Company	Trenz Electronic GmbH
PCN Number	PCN-20260219
Title	TEB0911-04 to TEB0911-05 Hardware Revision Change
Subject	Hardware Revision Change
Issue Date	2026-02-20

This change affects all Trenz Electronic TEB0911 boards: TEB0911-04*.

#20 Added test point (TP41, TP42, TP47, TP48).

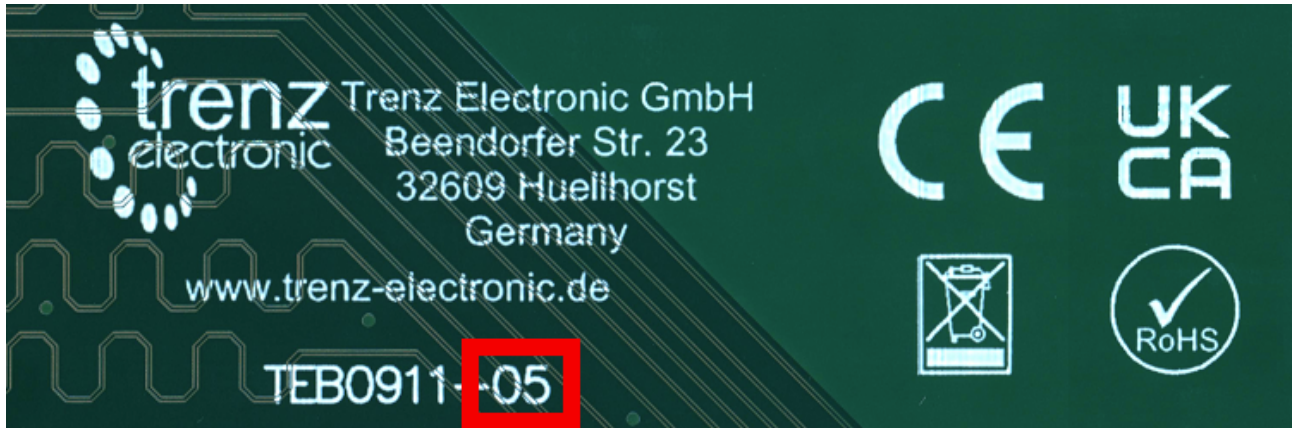
Type: Schematic Change

Reason: Voltage and system monitoring improvement.
